BREWSTER FIRE DEPARTMENT

BREWSTER YARDS

Review and Recommendations

FIG. 1 – Ladder Truck Access

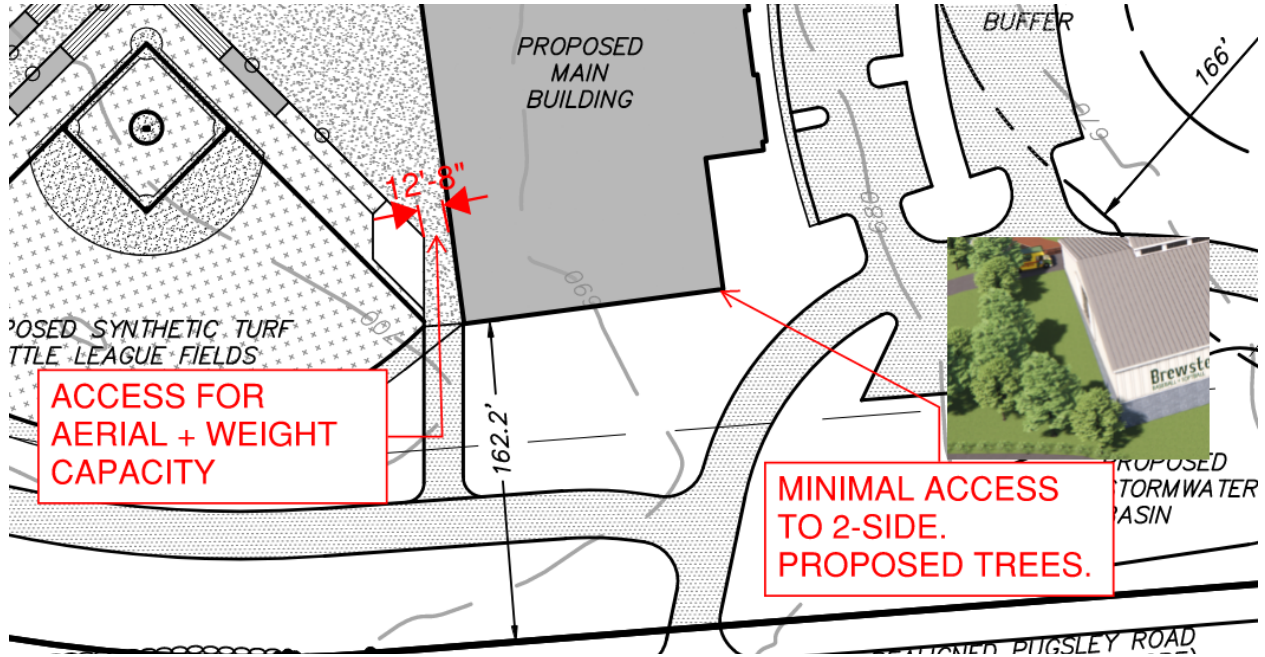
1. Recommend stairwell/deck/landing for emergency access/egress.
 - iii. Access to the rear of the building is by a delivery roadway that narrows down to approximately 12'-3" (see attached marked up drawing and below Fig. 1. **This should be wider** so we can get a ladder truck to the rear of the building.

1. The exact width of the ladder trucks are 8'-6". HOWEVER, to fully operate they require a minimum of **21'-0"** due to the fully extended outriggers. Outrigger pads must also be on sound bearing surface. GVW = 40 tons.

2. Ideal ladder placement is to access as many sides of the building as possible. This would mean right near the gate at the driveway.
 - b. Fields
 - i. There is minimal access to the center of the ballfields for EMS vehicles which are 8'-6" wide. The attached comments on the drawings show dimensions and areas for potential emergency vehicle access.
